Technical Memorandum for the Seward Park Mixed-Use Development Project FGEIS

CEQR Number 11DME012M Technical Memorandum 002

Figure 1

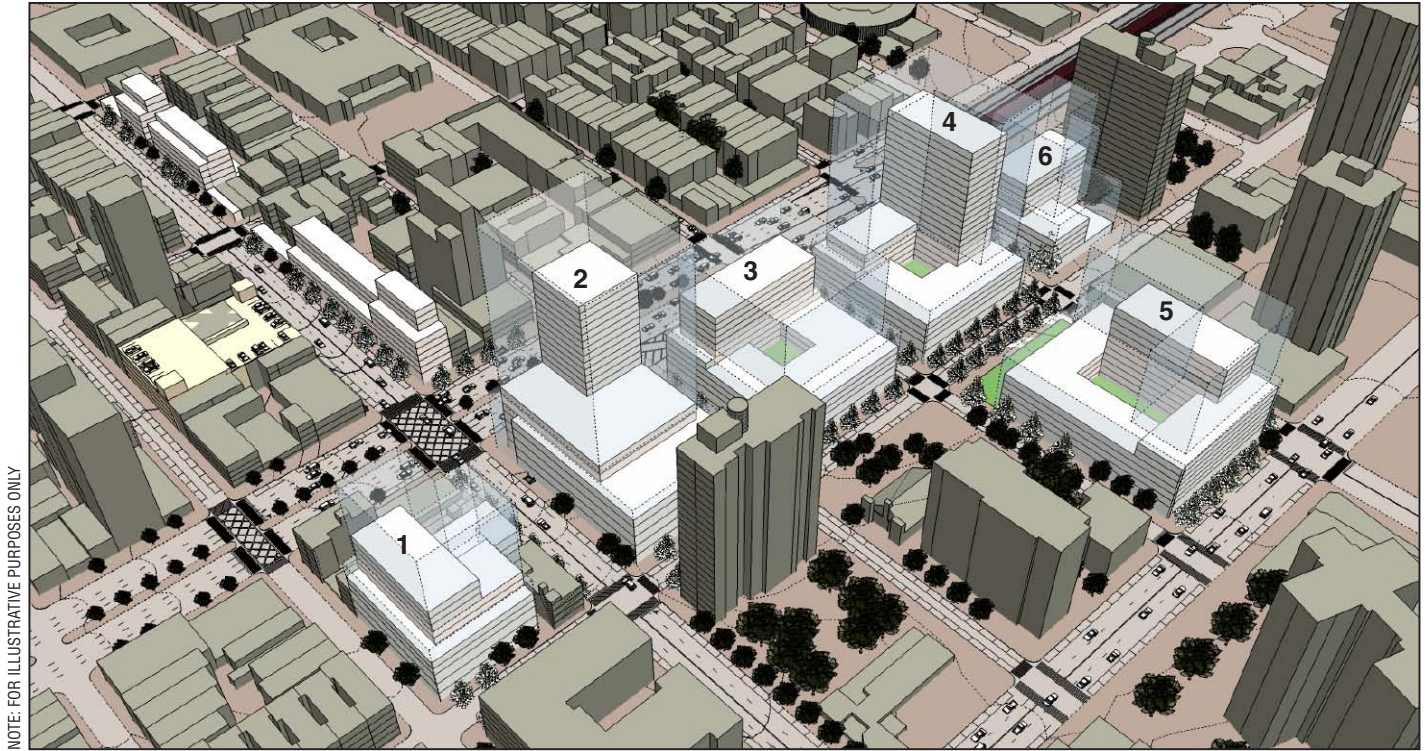
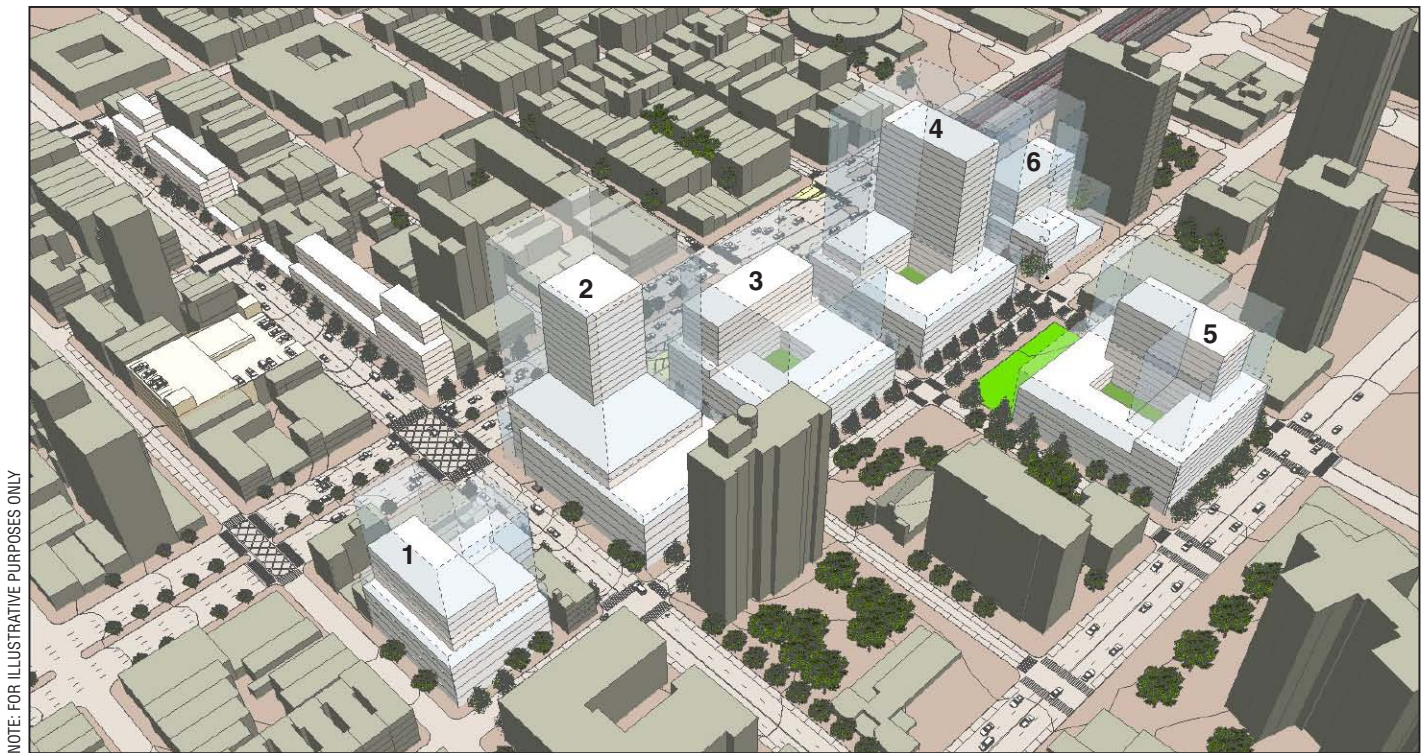
Under the proposed modification, the ULURP drawing set would be modified to increase the size of the publicly accessible open space included as part of the proposed development from

10,000 square feet, as assessed in the FGEIS, to 15,000 square feet. The proposed open space would continue to be located on the Broome Street portion of Site 5, as assessed in the FGEIS. For analysis purposes, it is assumed, as in the FGEIS, that approximately half of the open space would be dedicated to passive open space and the other half to active open space. To allow for the larger publicly accessible open space, the LSGD special permit pursuant to ZR section 74-743 would be modified in order to reduce the size of the maximum zoning envelope on Site 5, and the larger open space would be reflected in a revised Site 5 plan that would be part of the approved drawing set.

Under the proposed modification, the publicly accessible open space on Site 5 would have a footprint that is 25 feet deeper than assessed in the FGEIS (i.e., it would extend approximately 76 feet back from the property line on Broome Street, compared to 51 feet assessed in the FGEIS). Although the larger footprint of the proposed publicly accessible open space would shift the northern face of the maximum zoning envelope established for development on Site 5 back an additional 25 feet from Broome Street, the remaining dimensions—including maximum height—of the zoning envelope would not change. Therefore, the illustrative massings for a development on Site 5 would be similar under the proposed modification to the illustrative massings analyzed in the FGEIS (see **Figure 1**). Further, while the proposed modification would reduce the footprint for development on Site 5, it would still allow for NYCEDC and HPD to make approximately 15,000 square feet of land on Site 5 available to the New York City School Construction Authority for the potential provision of a school, as analyzed in Technical Memorandum 001.
